Accessibility Evaluation

Monroe County Polling Location

Christ Community Church
503 S High St
Bloomington, IN 47401

Report Date: 04/07/2026

Finding: 2

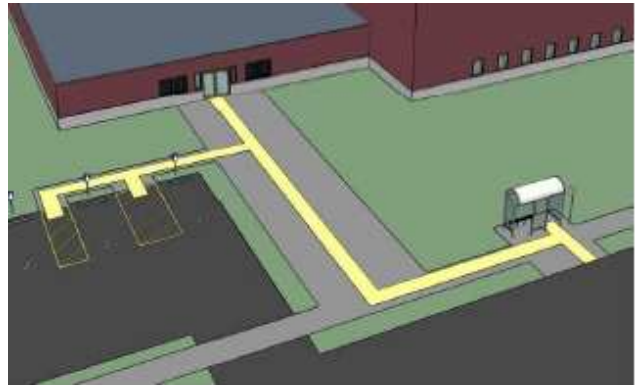
The accessible parking is not located on an accessible route of travel to the accessible building entrance.

Accessible parking spaces serving a particular building shall be located on the shortest accessible route of travel from parking to an accessible entrance. Where parking serves more than one accessible entrance, accessible parking spaces shall be dispersed and located closest to the accessible entrances.

Provide crossing guards on Election Day to help voters cross traffic.
